Cable and Thermal Derating Revisited

- **Move that the IEEE 802.3at Task Force adopt the following changes to the text in paragraph 33.1.4.2:**

Two pair vs. Four pair temp derating

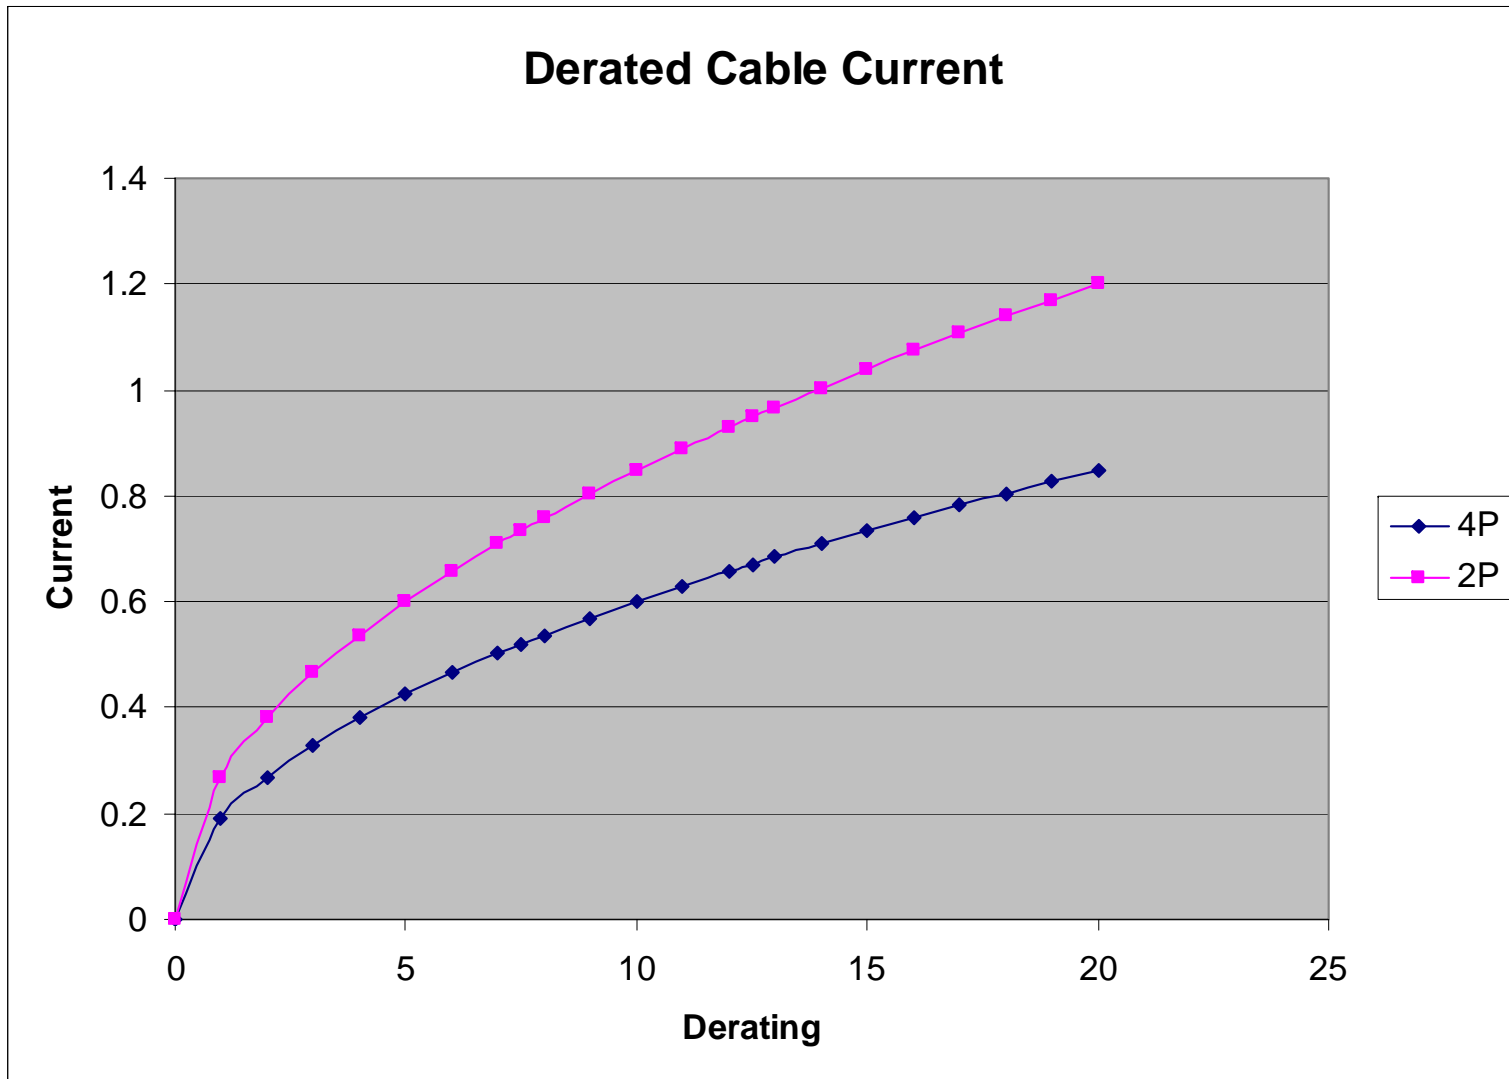
Two pair temperature derating

$$I_t = K \cdot \left(1 - \frac{t}{60}\right)^{0.5} \text{ A}$$

We can get more temp range...

current	4-pair	2-pair
424mA	5 C	2.5 C
600mA	10 C	5 C
735mA	15 C	7.5 C

- **Two pair**
- **600 mA**
- **5C derating**

Under worst case conditions, Type 2 operation requires a 10°C reduction in the maximum ambient operating temperature of the cable. Worst case operation assumes cable bundles with all pairs simultaneously energized at the maximum DC cable current specified in Table 33–1. **Type 2 operation that energizes two pairs requires a 5°C reduction.** Additional guidelines for the ambient operating temperature of Type 2 cables for 802.3at applications are addressed in ISO/IEC TR 29125 and TIA/EIA-TSBXX “Guidelines for Supporting Power Delivery over Balanced Twisted-Pair Cabling”.
